**AG-MI-2015-02-C-EN – Change of Measurement Method
from Cylinder Head Temperature to
Coolant Temperature**

Category C

Design change of the Rotax 912 ULS and Rotax 914 UL cylinder heads (introduced 01.03.2013) regarding the measurement procedure for cylinder head temperature (CHT) respectively coolant temperature (CT)

Fig. 1 – New generation cylinder head (measurement of CT)

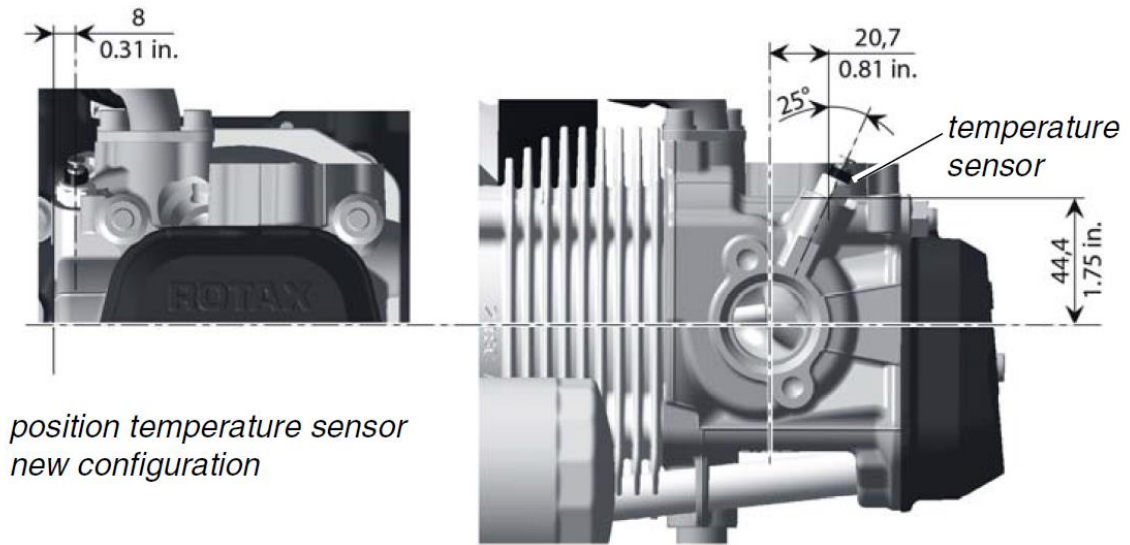
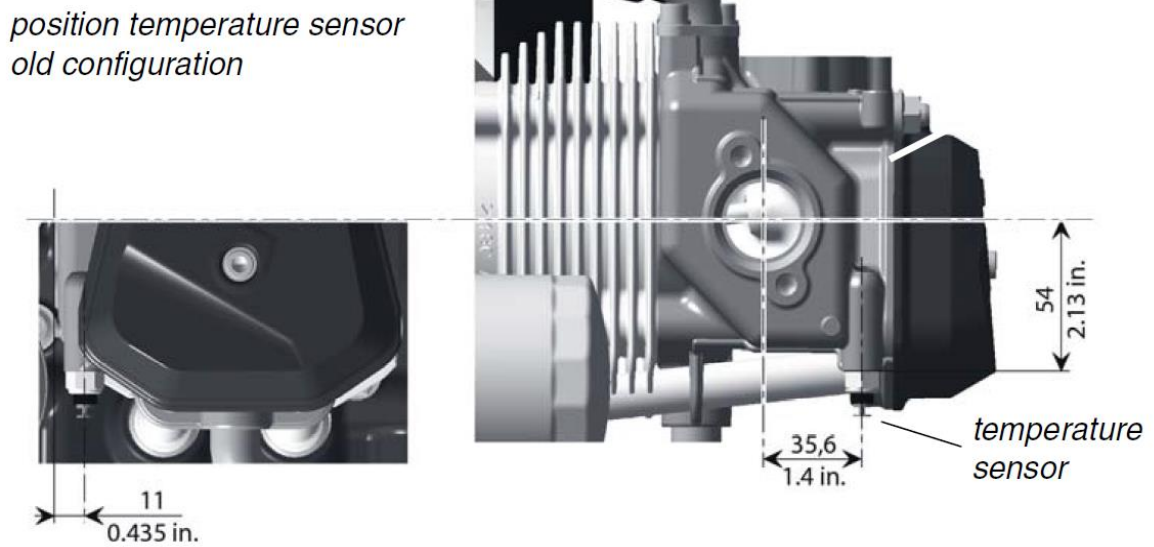
For engines equipped with new cylinder heads (see figures 1 and 2) change instrument marking of the cylinder head temperature indicator (CHT) to coolant temperature (CT). A replacement instrument will be purchasable later.

- 1 If necessary: Remove engine cowlings according to MMM 52-00-00 4-1
- 2 Check configuration state regarding cylinder head design (see figures 1 and 2)
If new cylinder head design is detected:
- 3 Clean CHT instrument glass with glass cleaner
- 4 Change cockpit instrument for cylinder head temperature (CHT) to coolant temperature (CT) using the modification set (see Parts List). Therefore in accordance with Fig. 3:
 - Stick the red radial on the instrument glass at 120°C
 - Stick coolant temperature pictogram on the instrument glass above "CHT"
